Request for Proposal (RFP) for Selection of Project Implementation Agency (PIA) for Various Connectivity through BharatNet Network

Corrigendum – III

Reference No: GFGNL/GFG/e-file/263/2022/0113/Commercial-Utilization

6th July 2023

Indicative Network Connectivity Diagram:

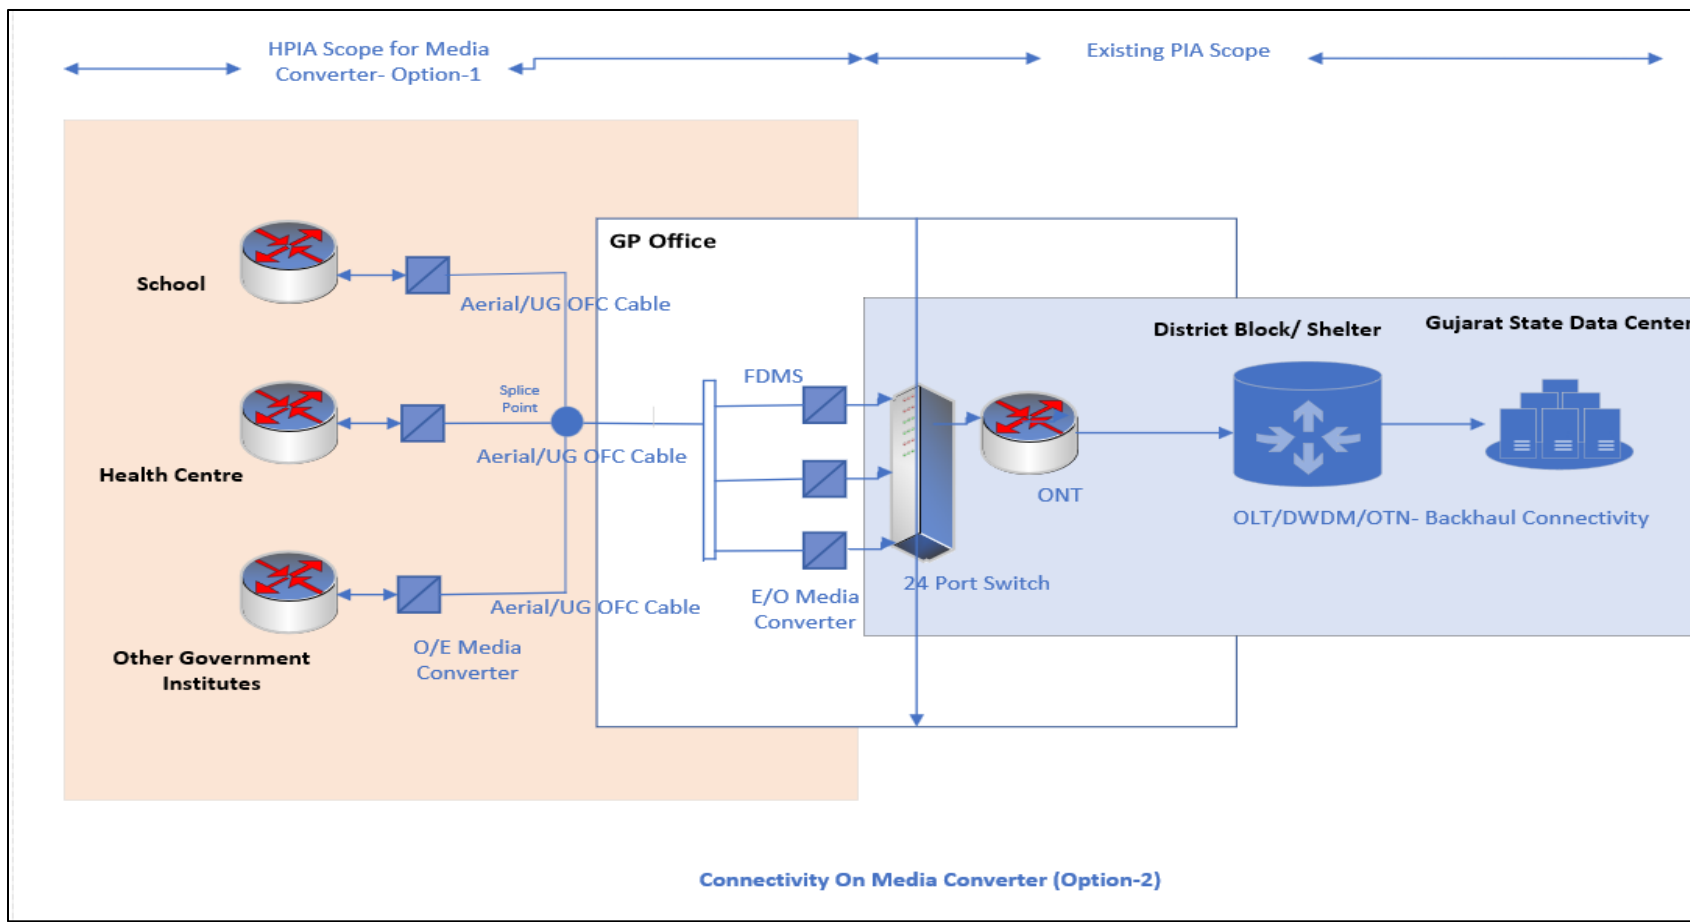
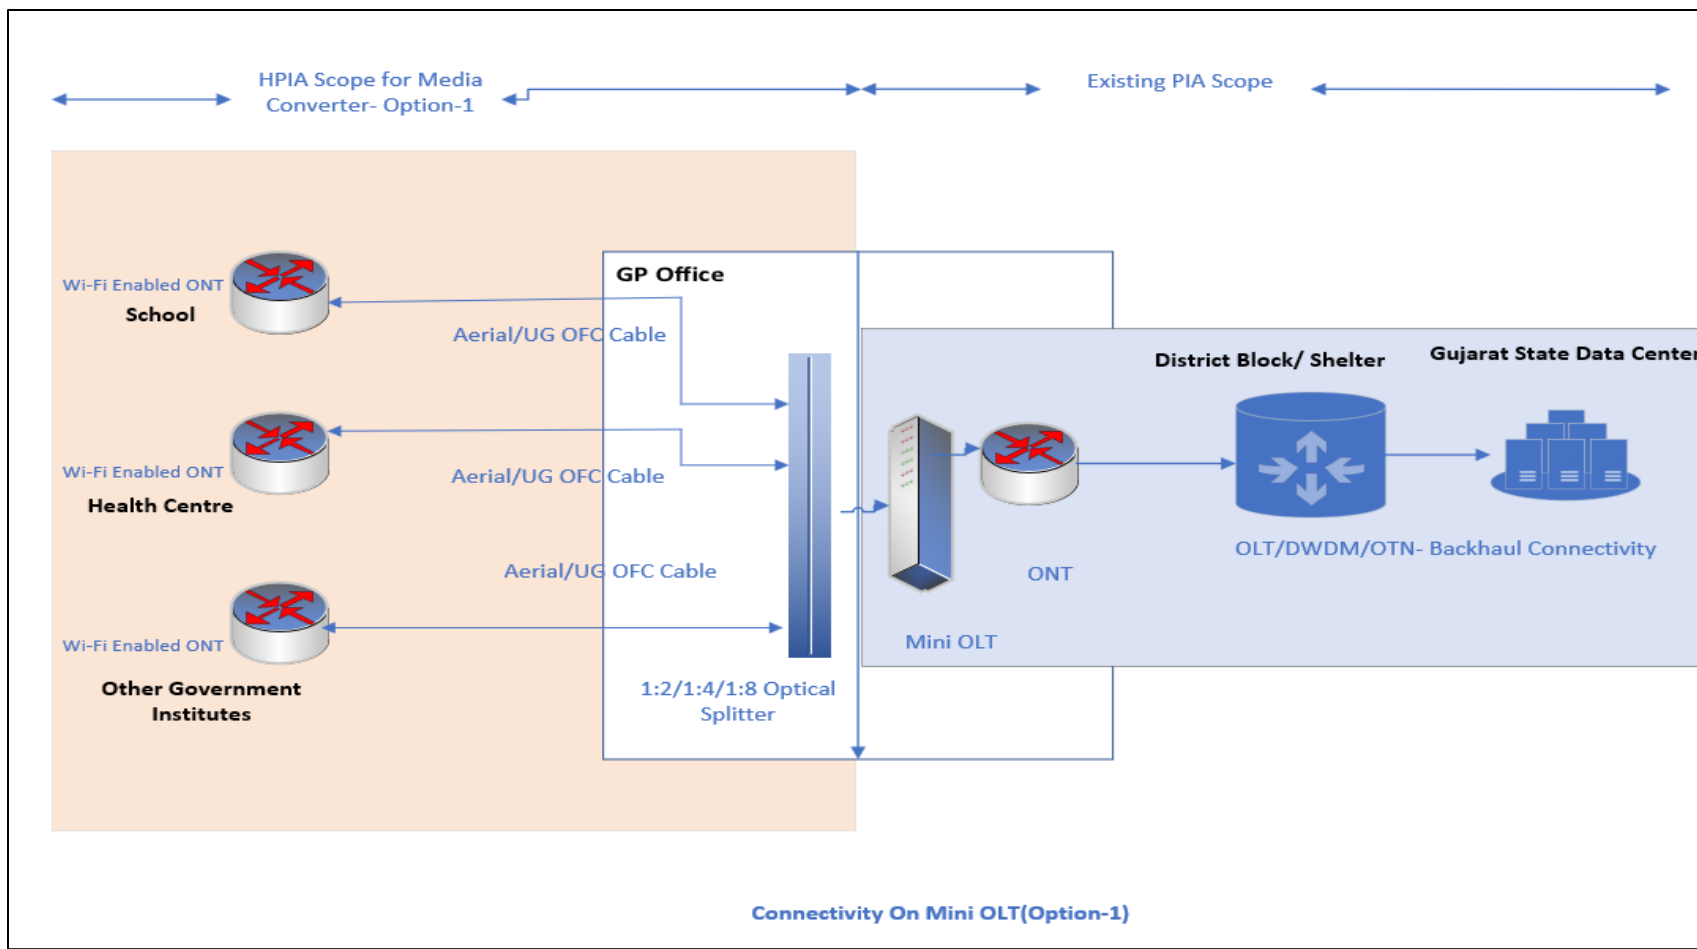
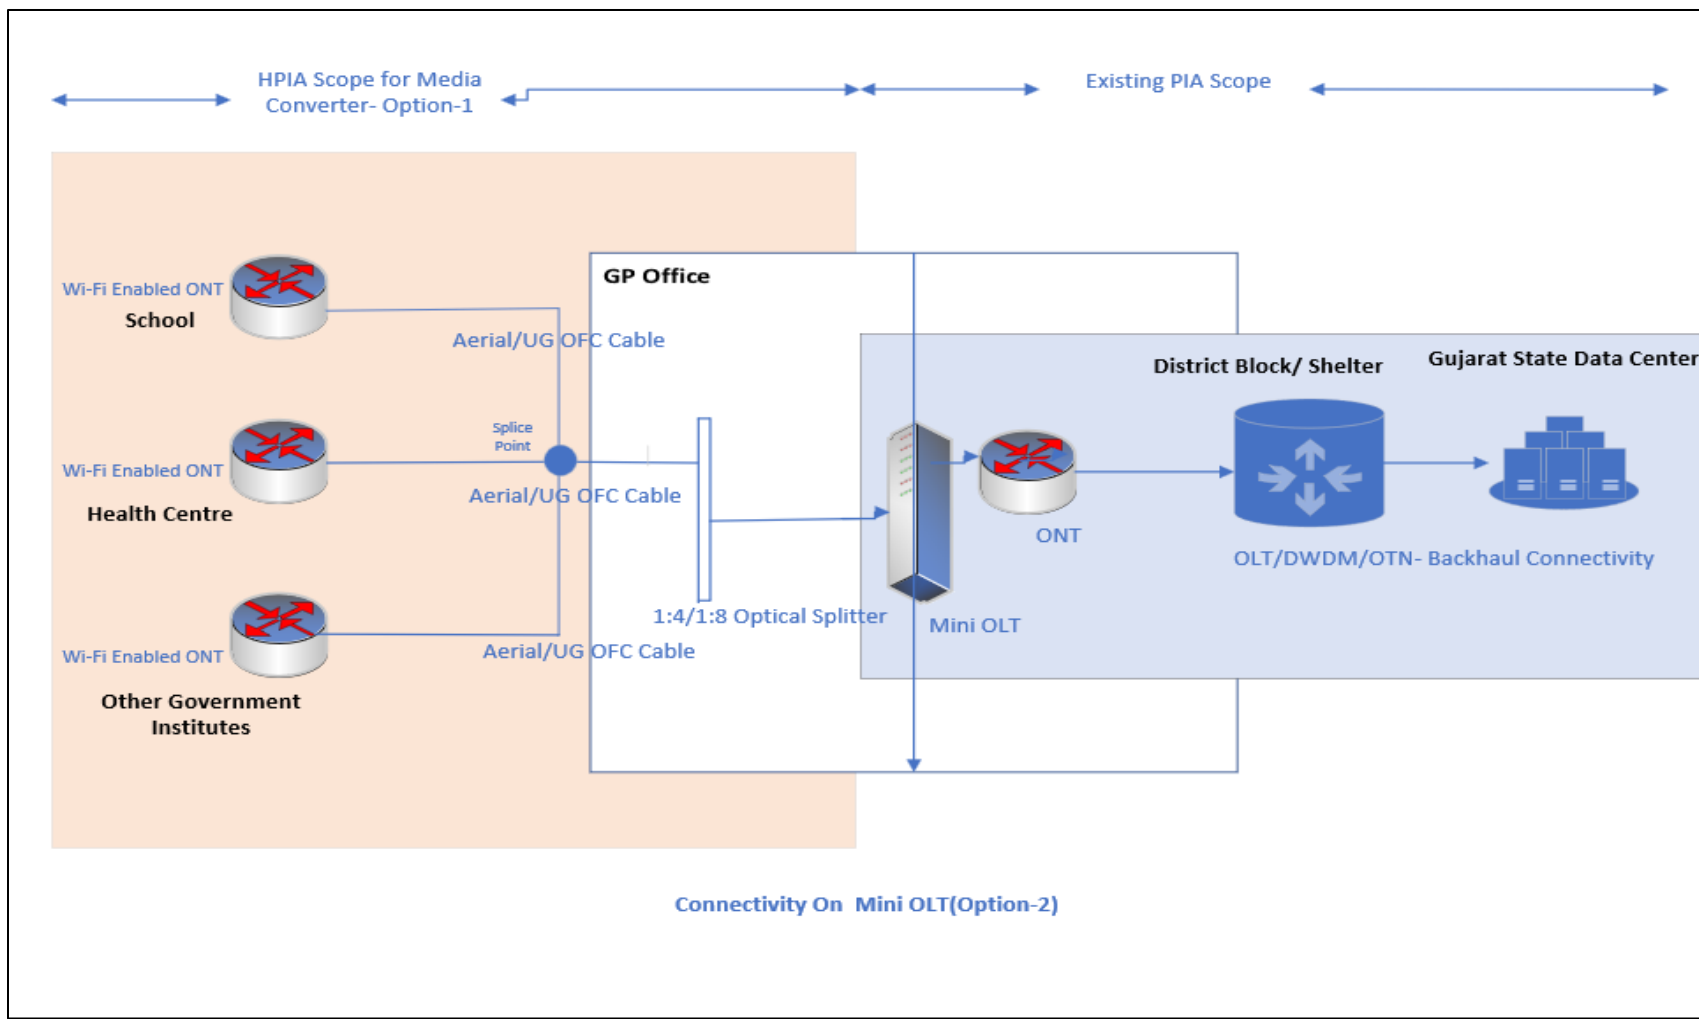
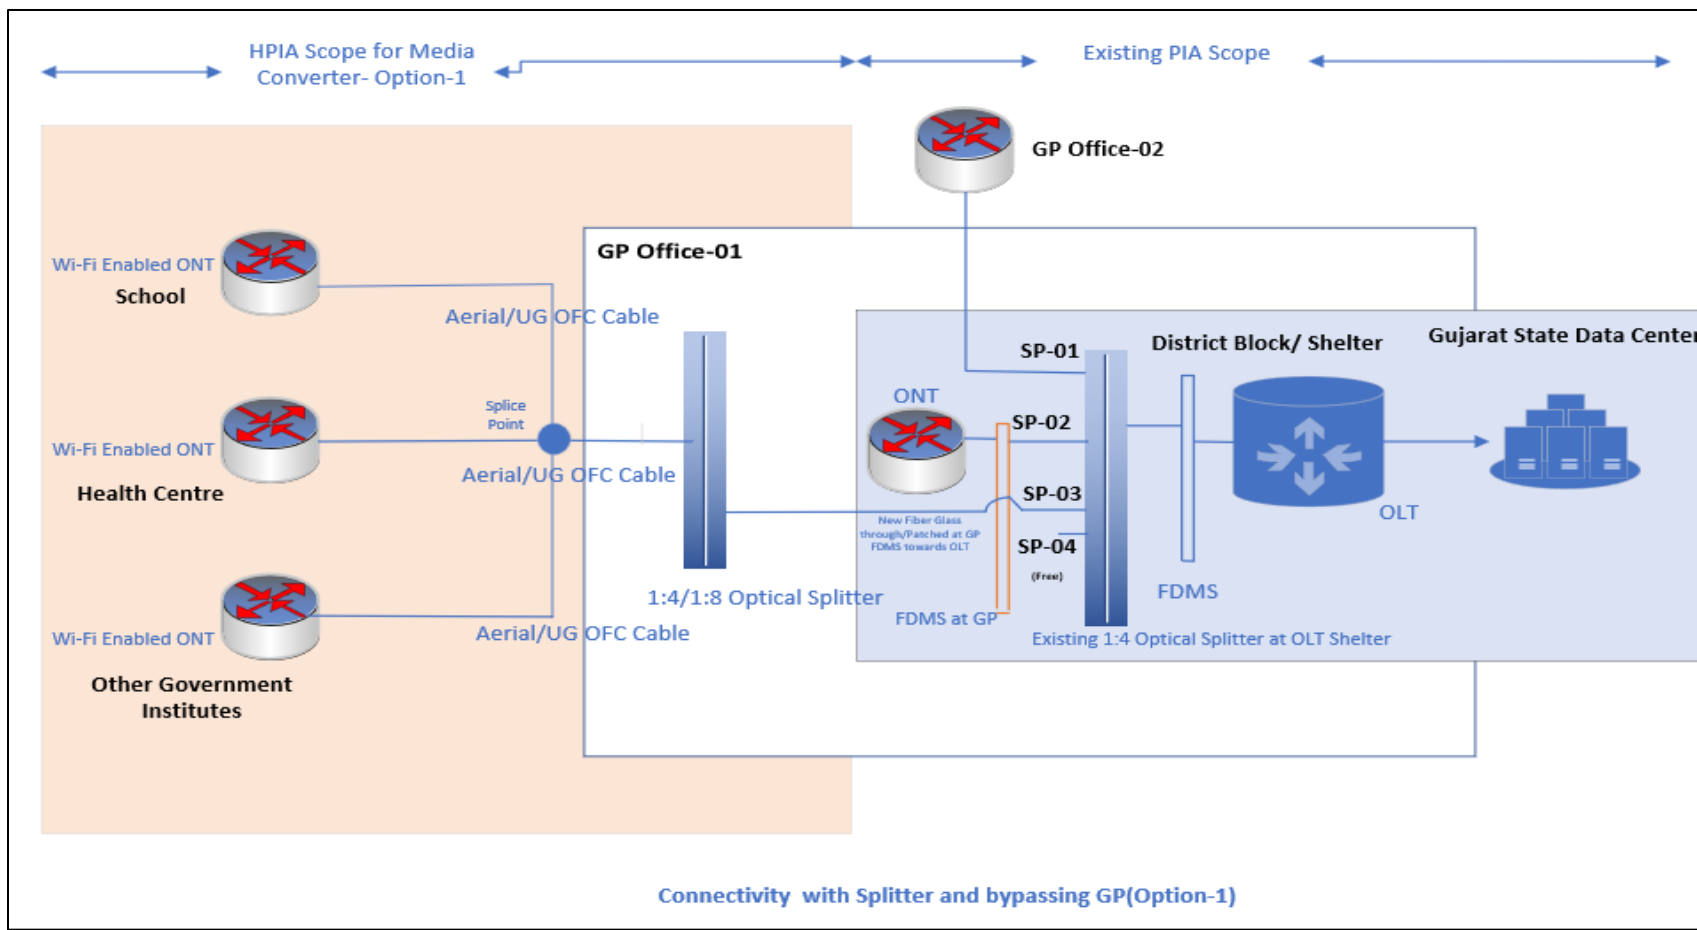
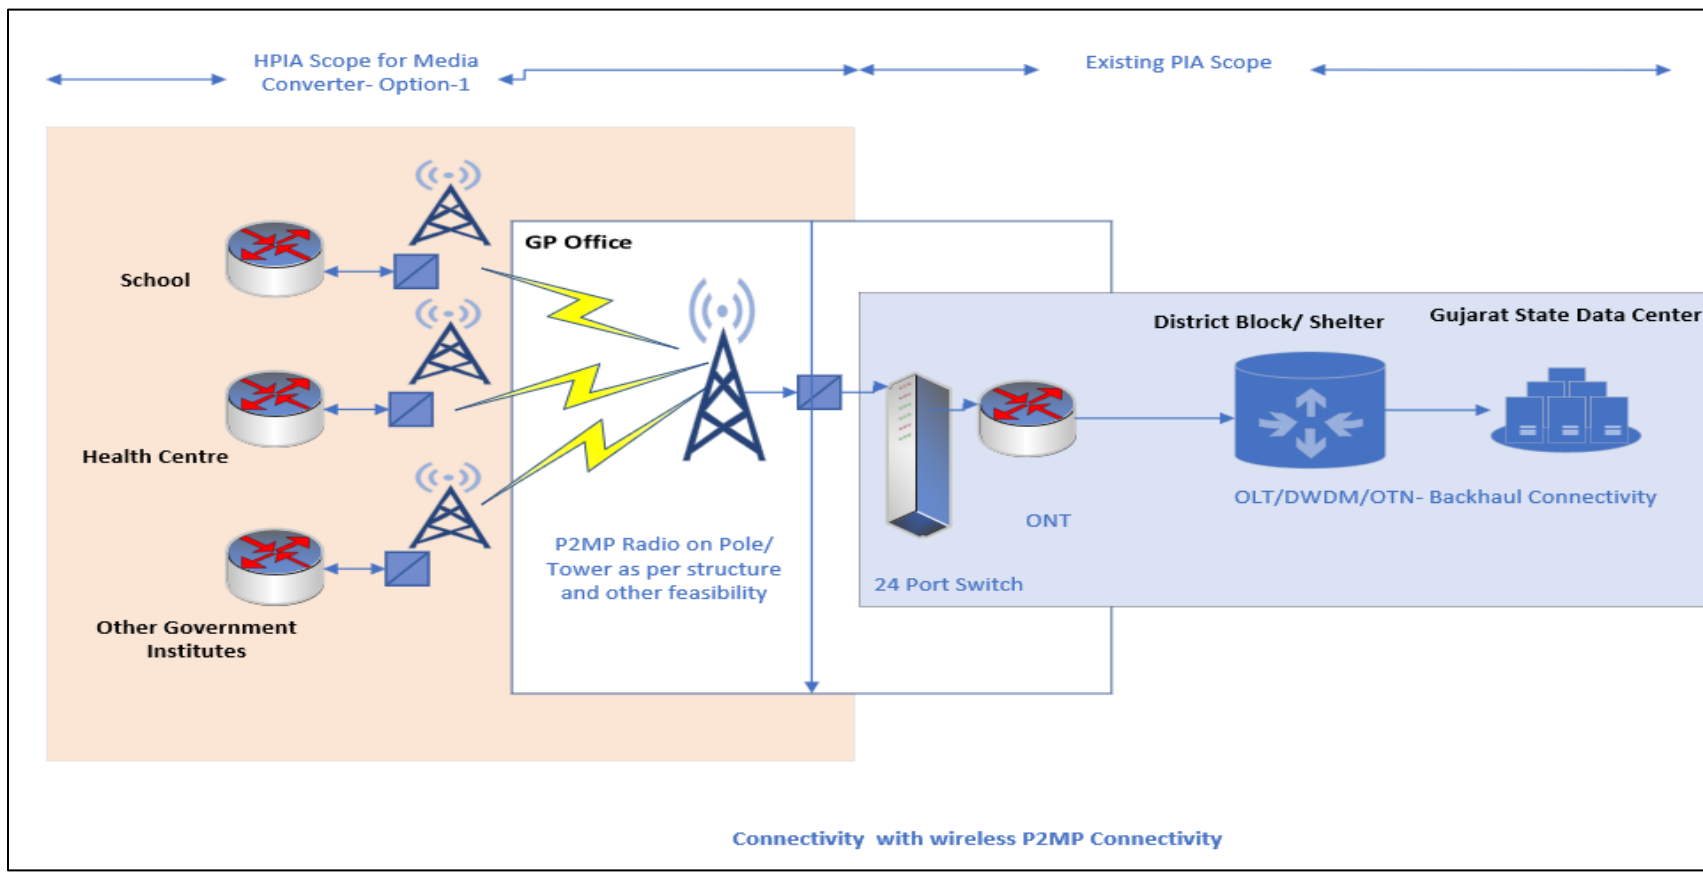
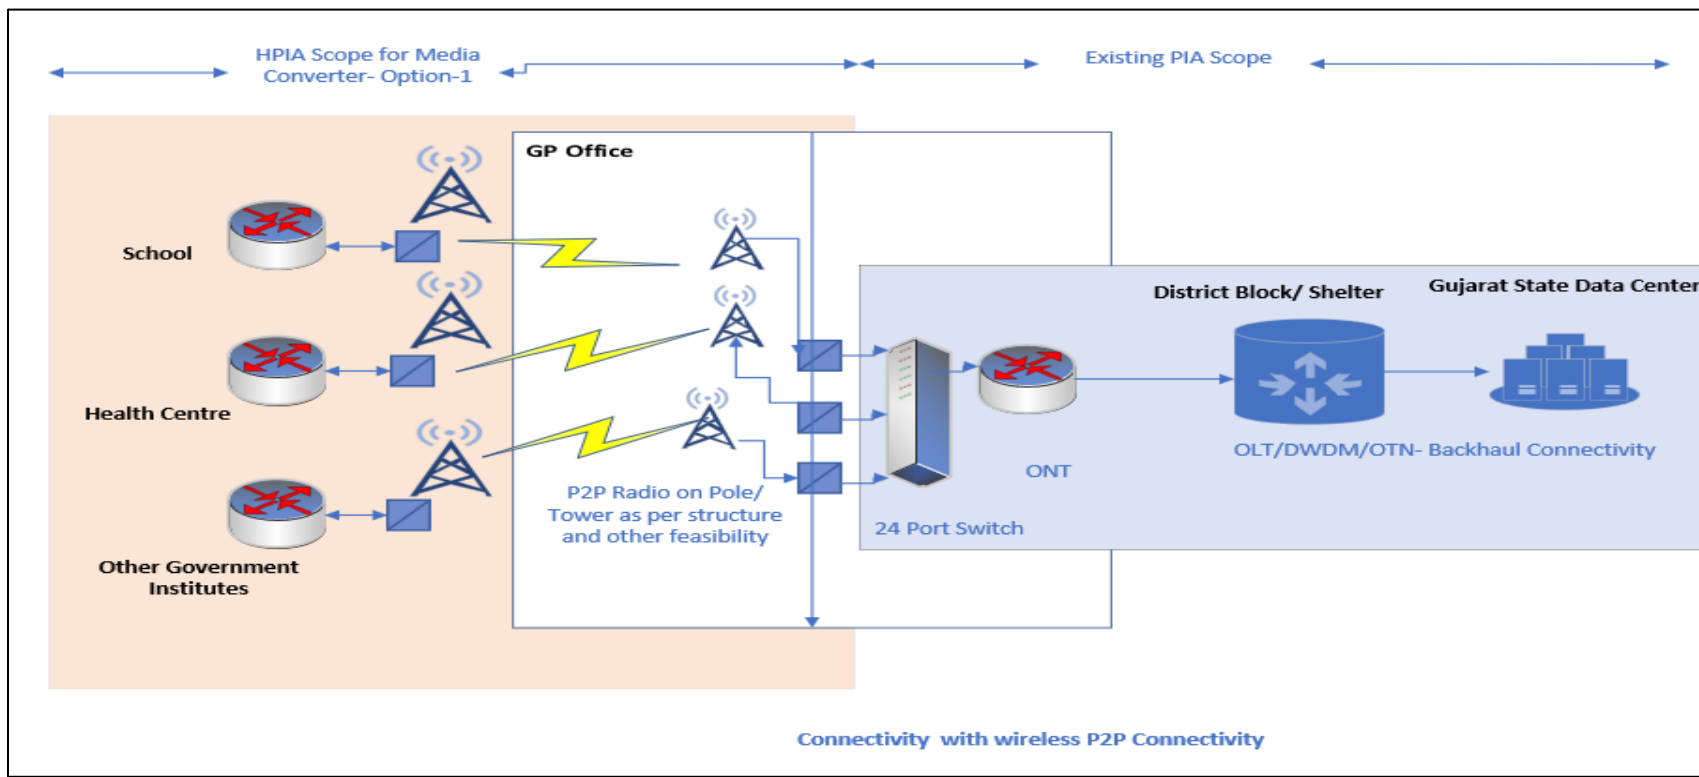
Sr. No	RFP Document Clause/ Section No.	Clause Title	Page No.	Content of the RFP Requiring Clarification	Clarification Sought	Response / Revised Clause
123	Add this Clause		New	we request share the Indicative network Connectivity Diagram which contains the Positioning of Active Components	we request share the Indicative network Connectivity Diagram which contains the Positioning of Active Components	Please refer corrigendum.
124	Add this Clause		New	Please add this New Clause "OEM Company is willing to provide the entire design and IP for review and security audit to, if asked for. Should be the same product brand with Network Operating System being the same as that of the supplied indigenous Product "	Please add this New Clause "OEM Company is willing to provide the entire design and IP for review and security audit to, if asked for. Should be the same product brand with Network Operating System being the same as that of the supplied indigenous Product "	Query not clear.
